Access Compliance Report Public Rights-of-Way (Curb Ramps)

Intersection ID: N/A Main Street: MCCLINTOCK_RD Cross Street: BASCOM_ST Location: SE

ADA ID: AF10D3764069 Ramp Type: Combination1 Initial Pass/Fail: Fail Overall Compliance: No Severity Score: 13.75

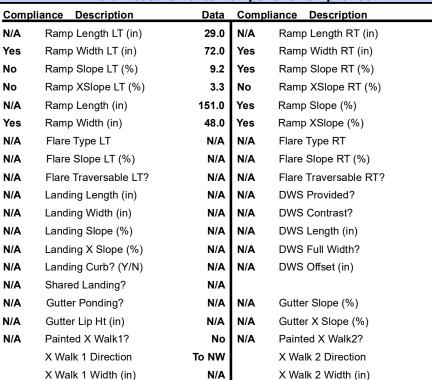
RT RP < 5%

Not Found, R304.3.2, R304.5.3

Remove & Replace Entire Ramp.
Remove & Replace Sidewalk.
